# Access Compliance Report

## Public Rights-of-Way

### (Curb Ramps)

Intersection ID: N/A	Main Street: INDEPENDENCE_RD	Cross Street: N/A	Location: E
ADA ID: 3D152EE856D7	Ramp Type: Directional1	Initial Pass/Fail: Pass	Overall Compliance: No
		Severity Score: 10

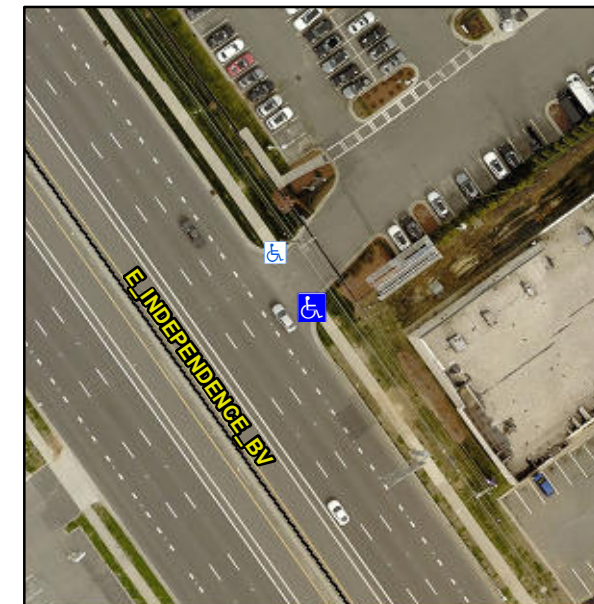
**Not Found, R304.2.2-Perp, R304.3.2-Para, R304.5.2, R305**

Compliance	Description	Data	Compliance	Description	Data
N/A	Ramp Length (in)	62.0	No	Grade Break?	No
Yes	Ramp Width (in)	72.0	N/A	Grade Break Slope (%)	3.5
Yes	Ramp Slope (%)	3.8	N/A	Grade Break XSlope (%)	0.1
Yes	Ramp XSlope (%)	0.7			
N/A	Flare Type LT	N/A	N/A	Flare Type RT	N/A
N/A	Flare Slope LT (%)	N/A	N/A	Flare Slope RT (%)	N/A
N/A	Flare Traversable LT?	N/A	N/A	Flare Traversable RT?	N/A
Yes	Landing Length (in)	64.0	No	DWS Provided?	No
Yes	Landing Width (in)	72.0	N/A	DWS Contrast?	No
No	Landing Slope (%)	3.3	N/A	DWS Length (in)	N/A
Yes	Landing X Slope (%)	0.8	N/A	DWS Full Width?	No
N/A	Landing Curb? (Y/N)	N/A	N/A	DWS Offset LT (in)	N/A
N/A	Shared Landing?	No	N/A	DWS Offset RT (in)	N/A
Yes	Gutter Ponding?	No	Yes	Gutter Slope (%)	1.0
Yes	Gutter Lip Ht (in)	0.0	Yes	Gutter X Slope (%)	0.1
N/A	Painted X Walk1?	No		Road Slope (%)	1.4
	X Walk 1 Direction	To NW		Road X Slope (%)	1.1
	X Walk 1 Width (in)	N/A		Clear Space?	Yes

**Remove & Replace Entire Ramp.**
